**AGENDA
ARCHITECTURAL COMMISSION
REGULAR MEETING**

**MEETING MINUTES OF THE
LONG GROVE ARCHITECTURAL COMMISSION
REGULAR MEETING
July 18, 2022
7:00 P.M.**

1) Consideration of a request for a new single-family home, 7237 Greywall Court and within the Concord Homes' Ravenna Planned Unit Development, submitted by Muhammad Khan, the future homeowner.

LEFT ELEVATION

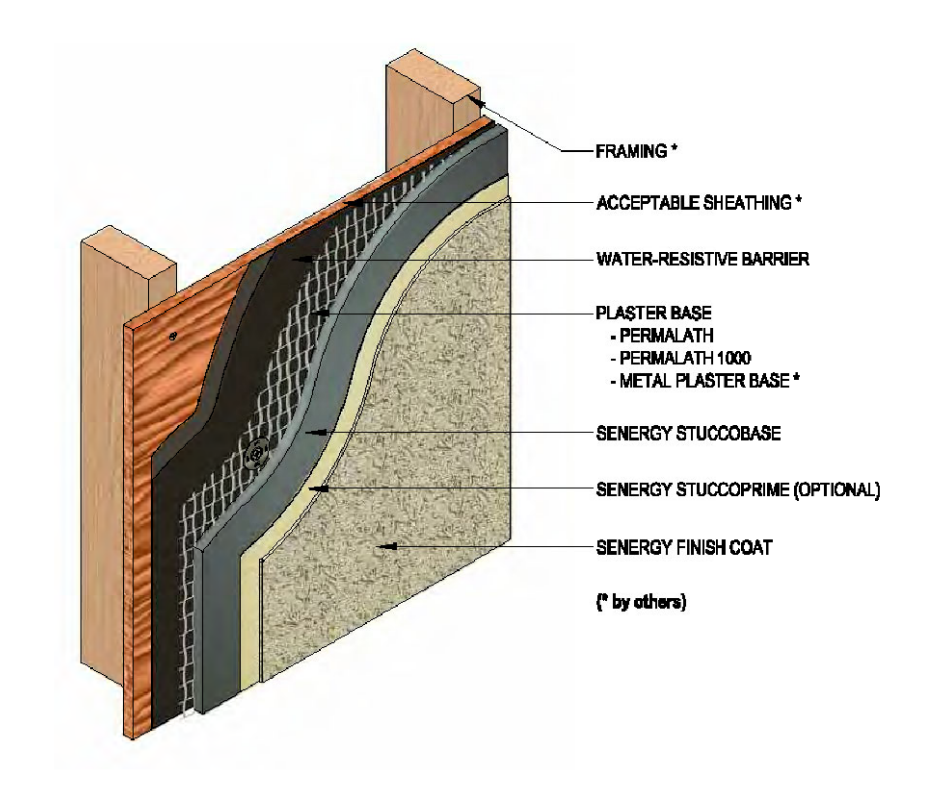
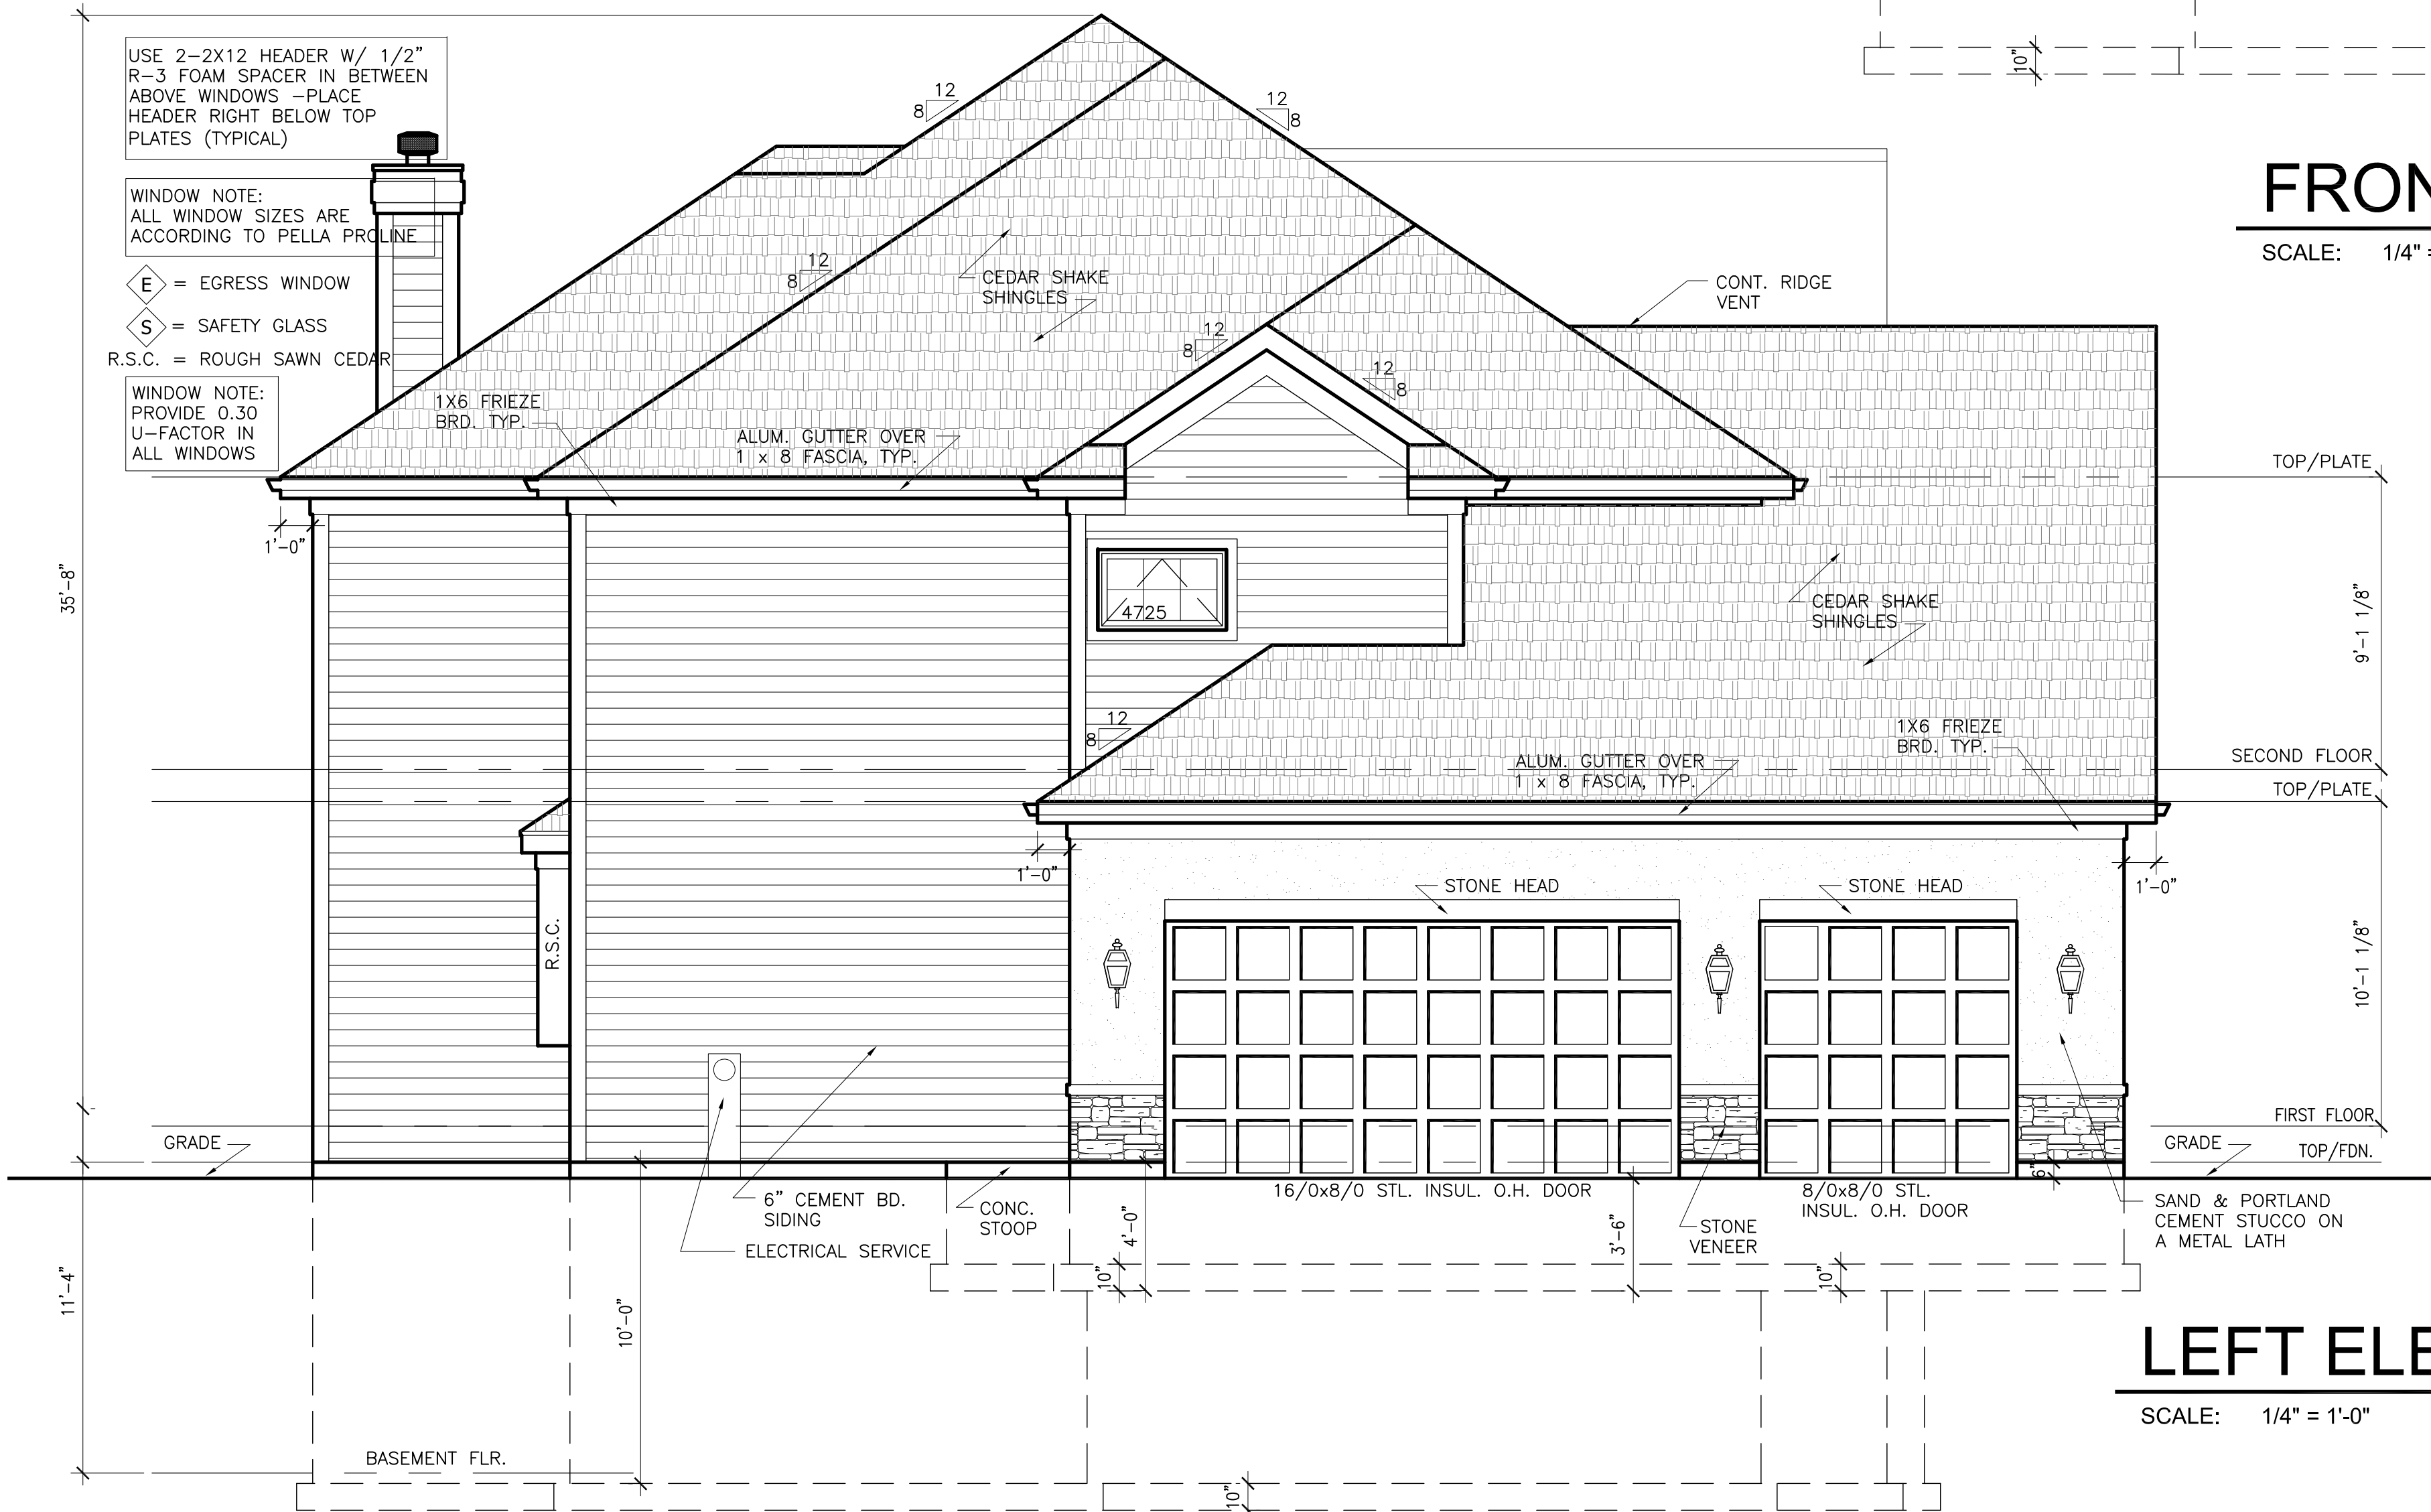
Chairwoman Sylvester had concern with the lack of variety of building materials on the left and right elevation. Commissioner Roiter agreed with her and added there is only one window on those elevations as well. He furthered explained that with new construction all four elevations should have a fair number of windows to provide consistency with the front and rear elevations. Commissioner Marshall wondered why the homeowner wouldn't want to have more windows on the other side of the living room since it isn't a private room.

The commission has also noticed the large amount of stucco used on the front façade of the proposed residence while most of the residences on Greywall Court are constructed out of masonry. Commissioner Roiter added there is a lack of stucco and all the other elevations.

Chairwoman Sylvester drove through this neighborhood and mentioned that other residences use a variety of different materials and rooflines. She thinks the proposed residences would better fit in this neighborhood's style by breaking up the massive flat face planes with different materials or ornamentations.

- The Commission had concerns about the lack of variety and consistency of materials and windows on the left, right, and rear elevations. Most of the residences in this neighborhood used a variety of different materials and rooflines. The Commissioners' suggested breaking up the massive flat face planes with different materials or ornamentations. Per the Anti Monotony Ordinance, the commission will not be recommending elevations with majority of the residences being siding. The Commission strongly encourages the applicant to incorporate the materials and windows used on the front façade into the remaining three façades.

1- We will do cedar shake shingles per plan attached. 2- Stone will be provided just as it shows on then drawings 3- The chimney was added to the Drawings, please see attached drawings 4-Please see attached stone picture. 5- The material colors were provided on the initial submission of documents. 6-We are working on the plan, but if you can approve the permit we will provide later. 7- The Rear elevation was updated with the sliding on the living room.
